# NITE-SITE, INC.

May 12, 1970

Re: License Number 22-13585-01  
Request for Modification

Model 70H - Front Unit

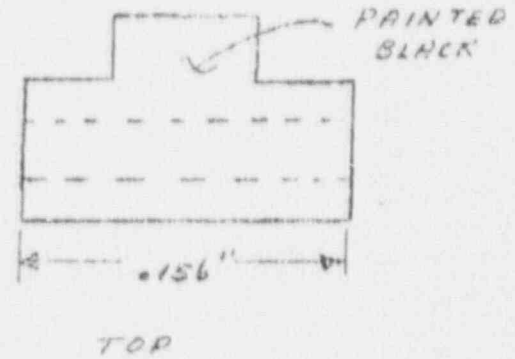
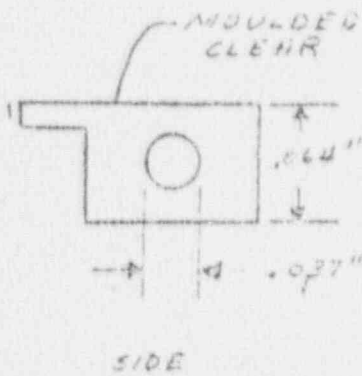
The original application referred to dimensions and configurations for front and rear sighting system referred as Model 69. These dimensions have been changed somewhat, with the housing still molded from lexan plastic, and the sealed source identical to that described in our original application, and these changes are shown in attachment 1. The modified sighting system for hand guns has been redesignated Model 70H. Basically, these changes involve squaring off the top of the front unit, providing a roughened under-surface for providing improved bonding characteristics, and providing downwardly extending tabs at each side for aligning the front unit and providing additional bonding strength. The rear unit remains basically the same, with the tab extending flush with the top of the rear unit.

Model 70S

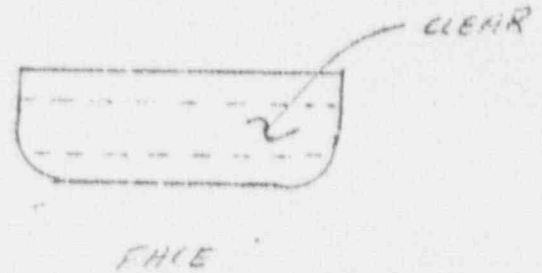
An alternative front sight housing, intended to be utilized primarily with shotguns, is designated Model 70 S. The radio luminescent source is a sealed luminous source of the type originally referred to, and will not exceed millicurie per unit. The Model 70S is also molded from lexan plastic, and has dimensions substantially larger

than the front unit for the Model 70H, or the Model 69, as originally licensed.
